SERVICE BULLETIN

No. SB-300-2-97

- Subject:** Fuselage structure / tail spring support
- Aircraft affected:** Following models and SN
EA-300/L: S/N 012, 014-170, 172, 173 and
1171, 1174-1299
EA-300/200: S/N 01-31 and 1032-1043
Aircraft that comply with Part II of issue (C) of this service bulletin are not affected.
- Purpose:** The combination of a redesigned tail spring support, a stiffer tail spring and rough field operations has led to cracks in the tail spring support mounting base.
Cracks have been reported even for airplanes that comply with PART II of the previous issue (A) of this service bulletin.
This issue D of the service bulletin is technically identical to issue C and provides instructions for recurring inspection and modification in the area of the tail spring support.
- Approval:** The technical content of this document is approved under the authority of DOA Nr. EASA.21J.073.

Figure 1: Possible crack locations in the area of tail gear spring attachment (retrofit plates of SB-300-2-97 issue A installed)

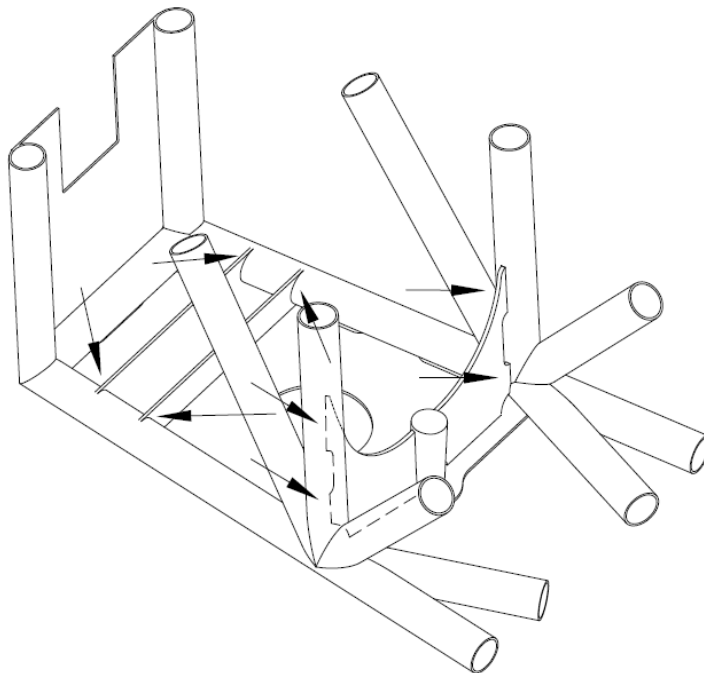
- Remove elevator control inspection window
- Visual inspection of tail spring mounting along welds to fuselage tubing. Cracks have been reported at the spots marked in figure 1. Investigate these areas carefully. To assist the visual inspection it is helpful to use a torchlight and a magnifying glass.
- In case cracks are found proceed with the instructions of PART II.
- In case no cracks are found reinstall elevator control inspection window and make appropriate entry of compliance in aircraft logbook.

Figure 2: Removing the fabric

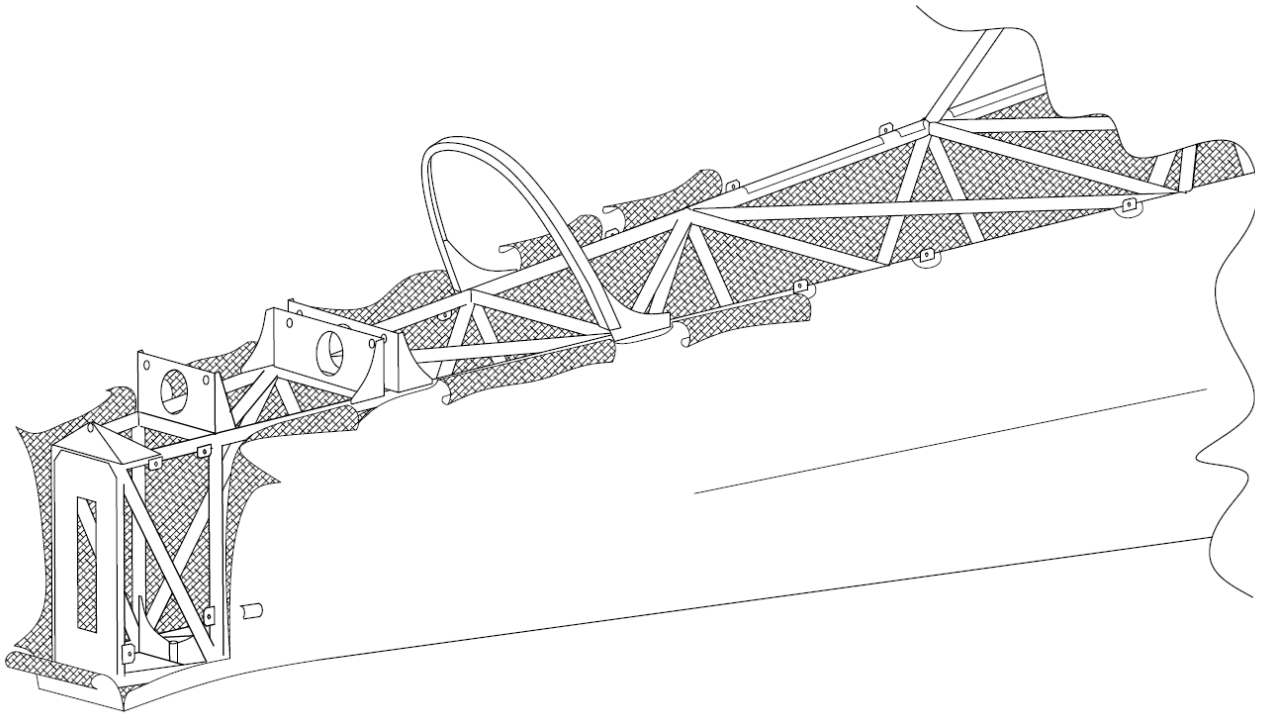
- Remove tail spring assembly, according Chapter 32 of the Service Manual.
- Disconnect battery ground wire and engine ground wire to firewall.
- Peel off fabric from upper L/H and R/H longeron, from rear facing fuselage surface and R/H lower longeron in the area of the inspection window (refer to figure 2 for detailed sketch). Do not use sharp objects that could damage the fabric while peeling it off. Fold the fabric far enough forward to have sufficient access to the area for welding. Make sure to work gently in order not to introduce cracks in the fabric paint coat finish.

Figure 3: Cutout for crack repair and retrofit

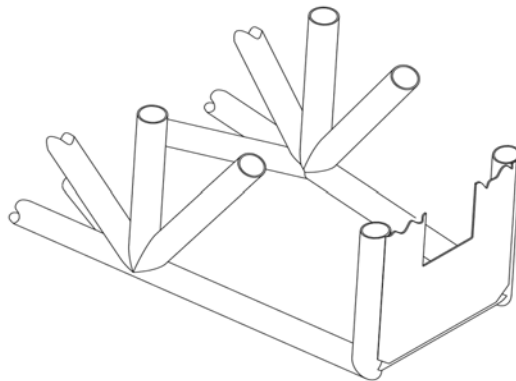
- Cut out tail spring mounting plate including front and rear stiffener (figure 3 shows detail of rear truss after cutting). Proceed with caution. Avoid damaging any truss tubes (except those tubes that are replaced).

Figure 4: Method of inner sleeve splicing, recommended for tubing crack repair
(ref. AC 43-13-1B, Aircraft Inspection and Repair, Chapter 04)

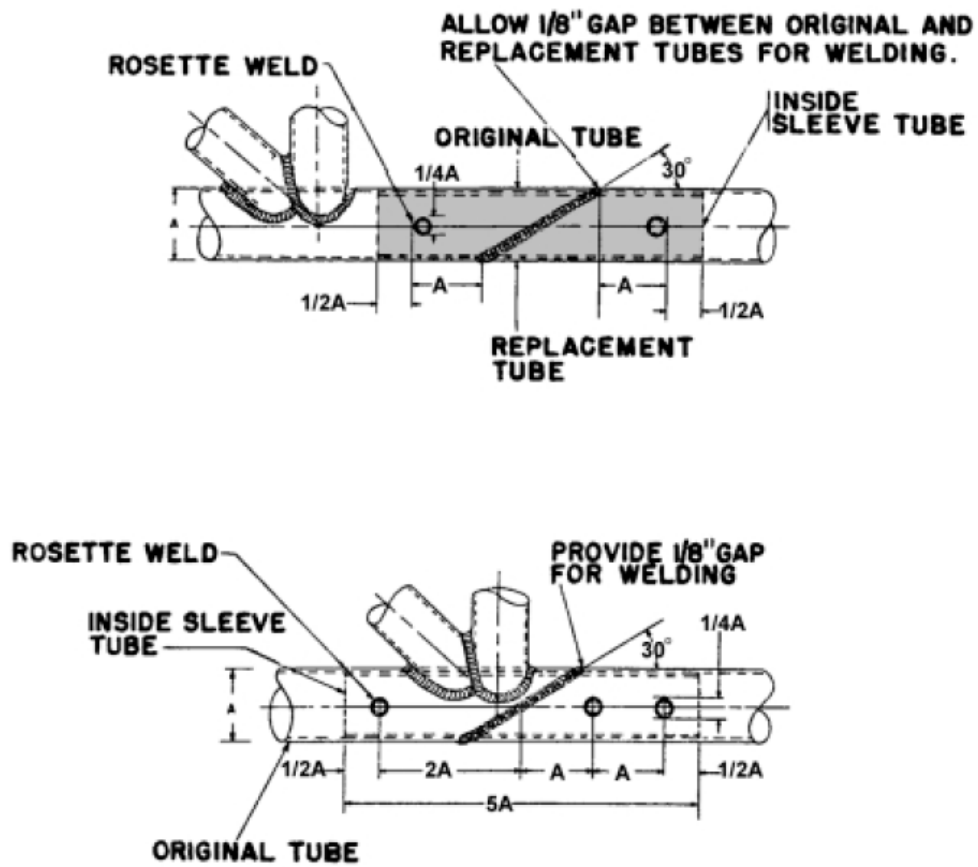
- Repair any cracks found. Refer to Chapter 51-70-05 "Structural Repair of Steel Components" of the Service Manual and figure 4.
- Weld retrofit plates in place, refer to figure 5 for correct position of plates and welds.
